SITE PLAN APPLICATION

NAME OF PROPOSED DEVELOPMENT Arby's Restaurant

SITE PLAN

- B. P&Z 87-60-SP - Discuss and Consider Approval of a Site Plan for Arby's Located at FM-740 and I-30

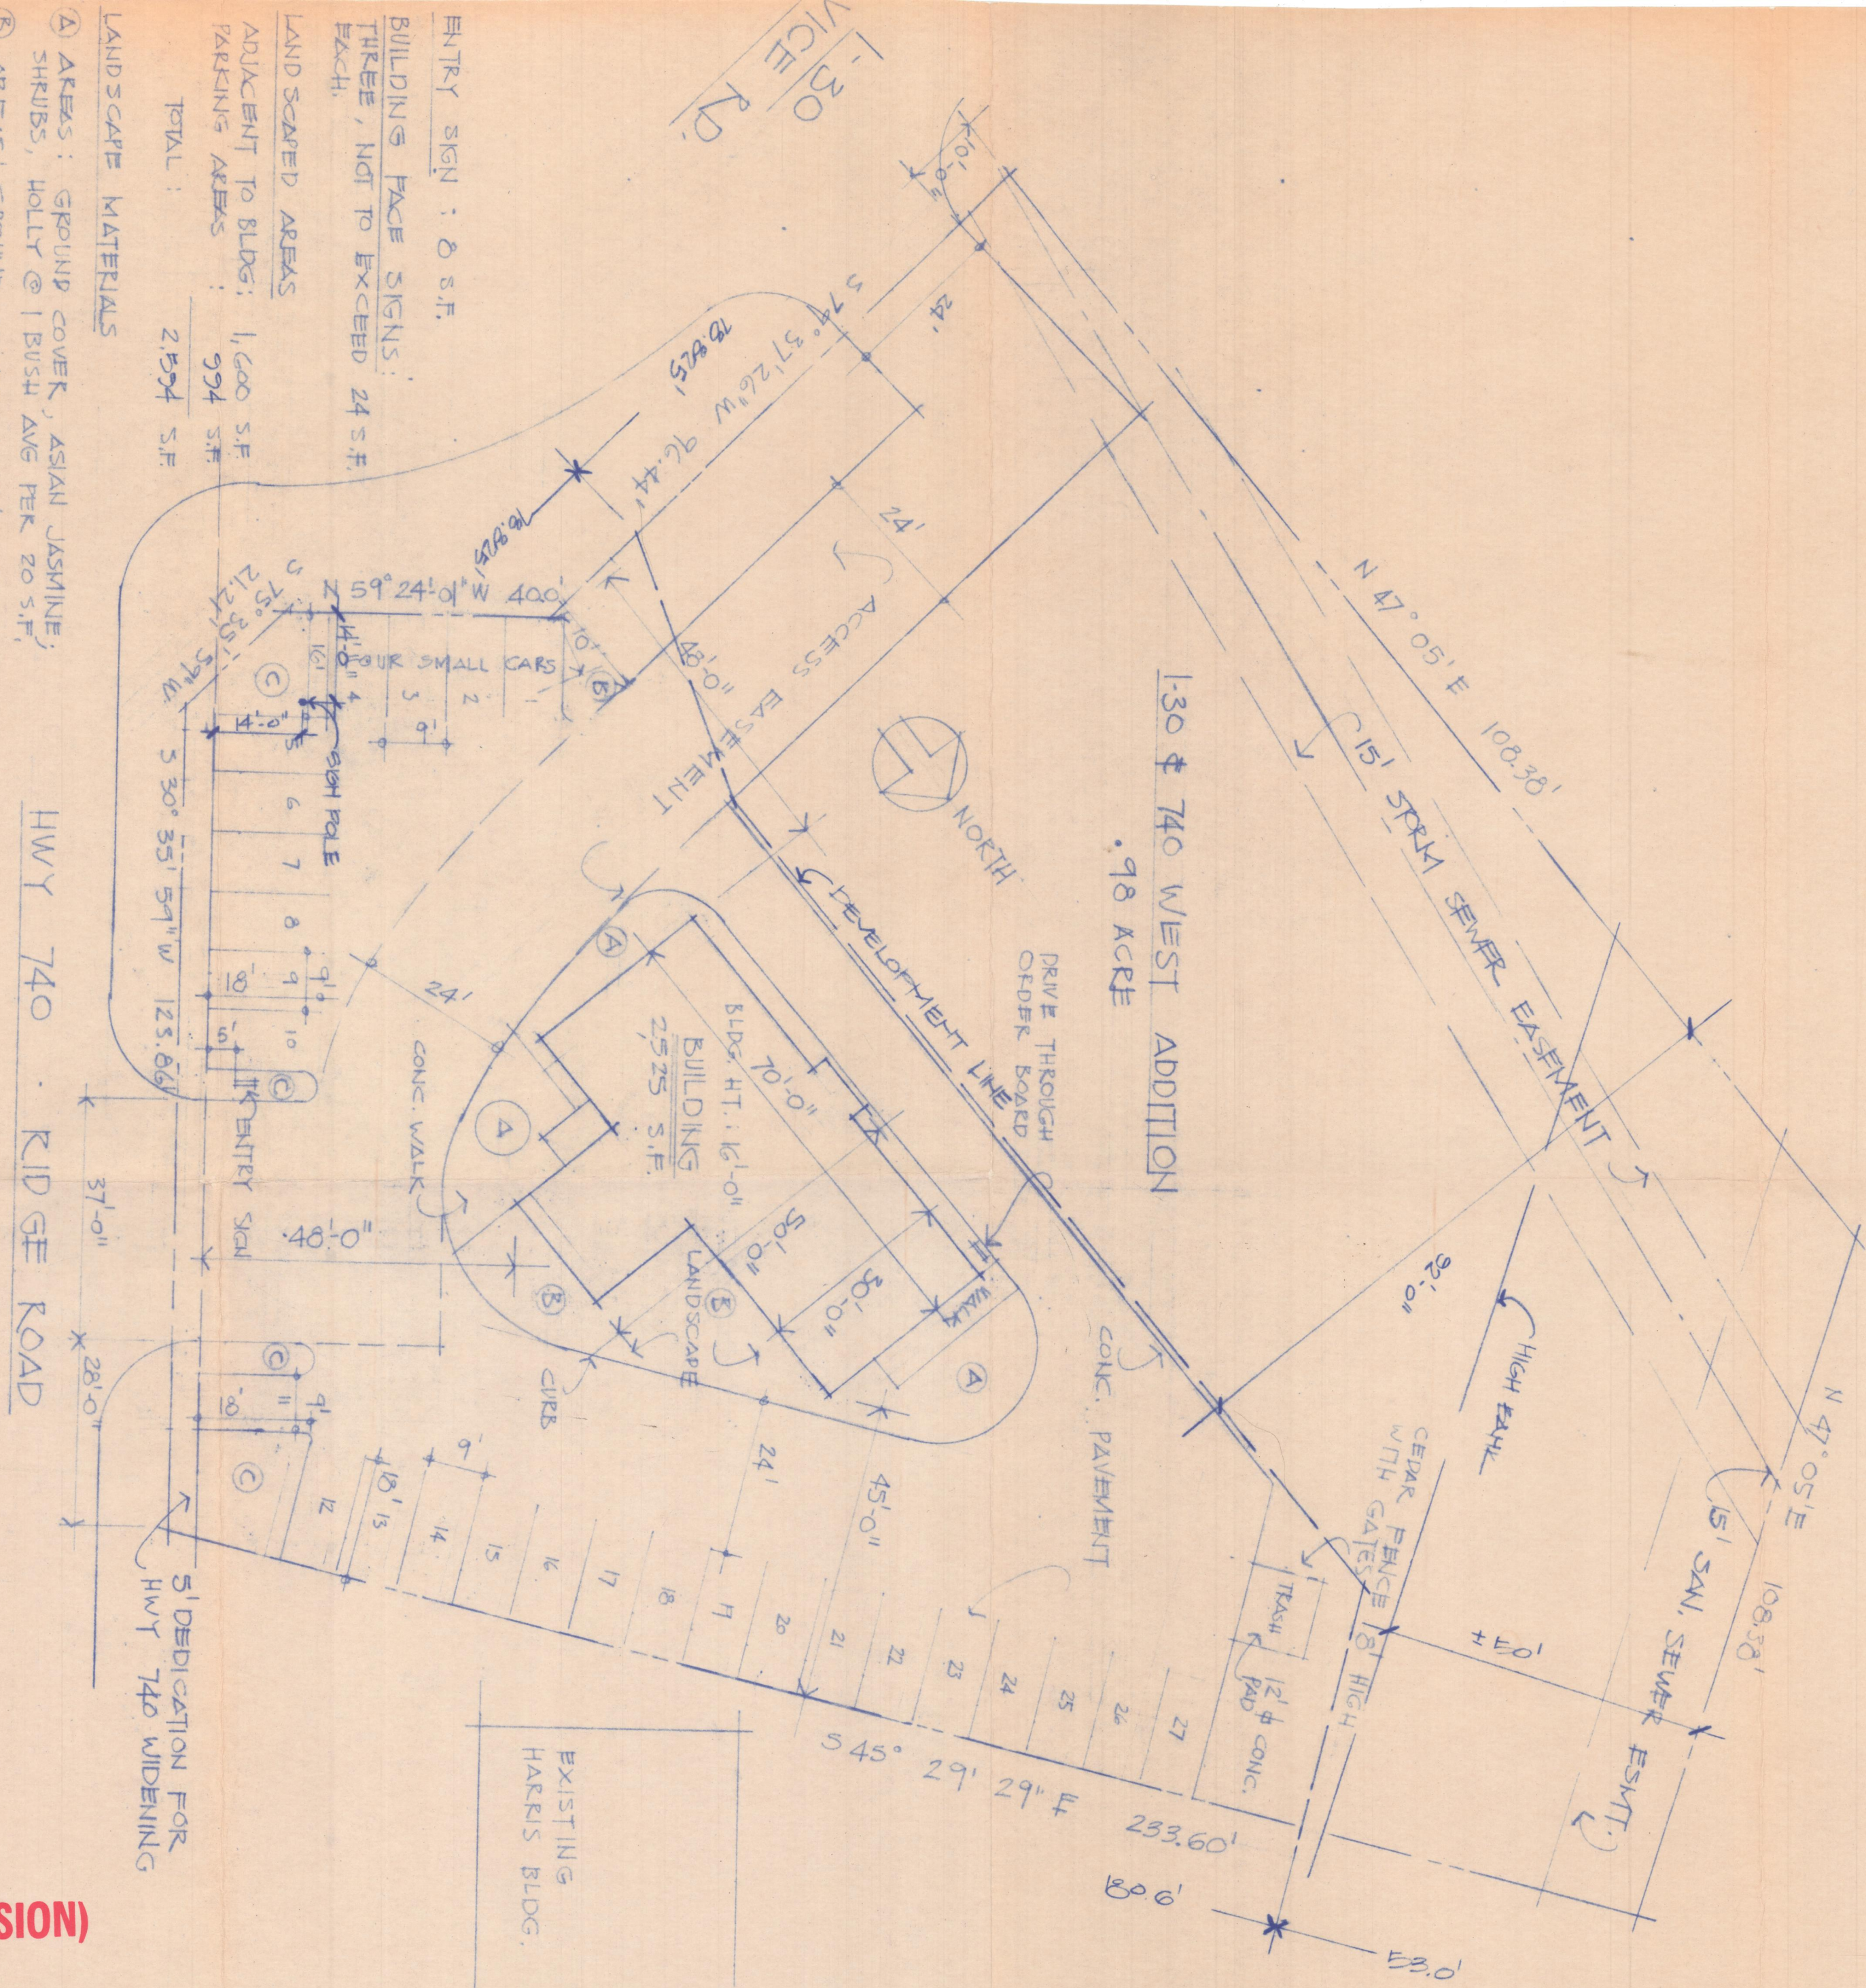
| g. Is coverage correct? <i>what area of site?</i> | _____ | _____ | _____ |
| p. Are parking spaces dimensioned properly <i>how is flow going to work</i> | _____ | _____ | _____ |
| q. Does the parking lot meet City specifications <i>parking overhang on City</i> | _____ | _____ | _____ |

- * 7. Does the site plan contain all required information from the application checklist?
- 8. Is there adequate access and circulation?
- 9. Is trash service located and screened? *show us flow going to work*
- * 10. Are street names acceptable? *NA*
- 11. Was the plan reviewed by a consultant? (If so, attach copy of review.)
- 12. Does the plan conform to the Master Park Plan?
- 13. Are there any existing land features to be maintained? (ie, topography, trees, ponds, etc.)

*either enough room to circulate of behind adjacent yard for trash service.
show us the traffic going to flow*

- 1. Does plan conform to Thoroughfare Plan?
- 2. Do points of access align with adjacent ROW?
- 3. Are the points of access properly spaced?
- 4. Are street improvements required?
- 5. Will escrowing of funds or construction of substandard roads be required? *what about curbing on 740*
- 6. Does plan conform with Flood Plain Regulations?
- 7. Is adequate fire protection present?
- 8. Are all utilities adequate?
- 9. Are adequate drainage facilities present?
- 10. Is there a facilities agreement on this site?

- 11. Are existing roads adequate for additional traffic to be generated? ✓
- 12. Is the site part of a larger tract? Does the plan adversely impact development of remaining land? ✗
could adversely impact adjacent land
- 13. Are access easements necessary? ✓
what are the roads
- 14. Are street and drive radii adequate? _____
what are the radii
- 15. Have all required conditions been met? _____ ✓
- 16. Is there a pro rata agreement on this site? _____ ✓
- 17. Have all charges been paid? _____

SITE PLAN

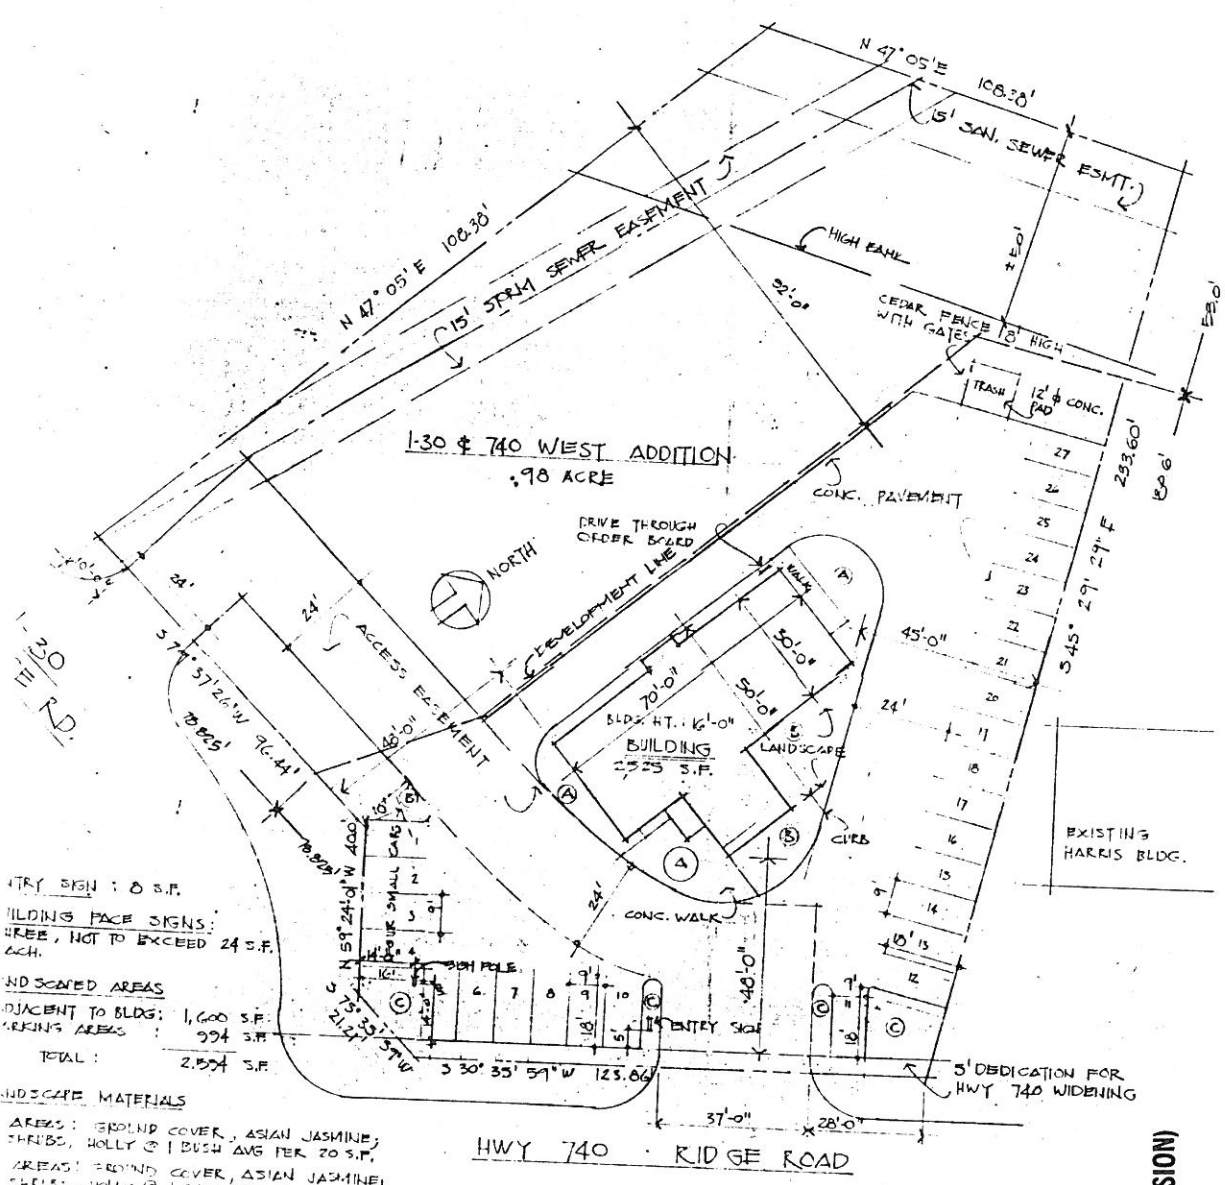
The site plan as submitted meets our minimum requirements for setbacks, parking, and landscaping. The only comment that we had on the site plan was some concern about traffic congestion with the proposed parking along the east property line and traffic that is stacked, waiting to go through the drivethrough. This arrangement will work fine if only 3 or 4 cars are stacked, but it could result in some congestion if there are more. We have requested the property owner to address this at the meeting. As we mentioned, they are also contemplating moving the western boundary some feet to the west to provide more frontage for this site on I-30.

They have provided for a five foot dedication of right-of-way along FM-740 for its future widening on the site plan. This dedication should be included in the motion regarding this item.

The site plan as submitted meets our minimum requirements for setbacks, parking, and landscaping. The only comment that we had on the site plan was some concern about traffic congestion with the proposed parking along the east property line and traffic that is stacked, waiting to go through the drivethrough. This arrangement will work fine if only 3 or 4 cars are stacked, but it could result in some congestion if there are more. They believe that with adequate signage and striping, as well as moving the order board, they will eliminate potential congestion.

The Planning and Zoning Commission approved the plan subject to dedication of 5 feet of right-of-way along FM-740. While we did not specifically address the time of dedication at the P&Z meeting, we need to establish when that will occur. The property owner is willing to tie it to the issuance of a building permit and we believe this would be appropriate.
